Process Sheet

: CC-DAR01 Dart Aerospace Ltd.

Part Number **Drawing Number** : D35645 : OPEN TABS

D3564-5 WEARSHOE

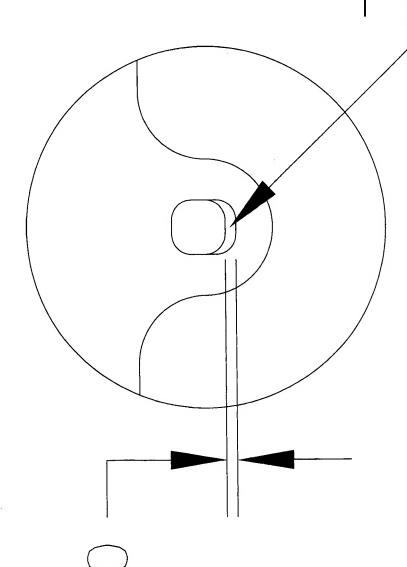
· USE FOR 0412-742-011/-013 Assembly only

· Re-work tabs as indicated below

PH 03.04.17 REMOVE MATERIAL

We are trying to ship a 206L/407 float skidtube with stainless steel wearplates and the rubber gasket. Upon assembly we have found that the extra thickness the gasket gives, causes a diffcult fit for the wearplate.

Jason opened the holes on the tab and the bolts not fit properly, to join the wearplates to the skidtube (see the attached pictures). We would have to open up all the wearplate tabs.

Is this an acceptable deviation for this shipment?

For future shipments the flat pattern will need to be updated.

This is an acceptable deviation to me.

However, the parts have to be cleaned up considerably from what I saw in the pictures (deburred and paint touched up).
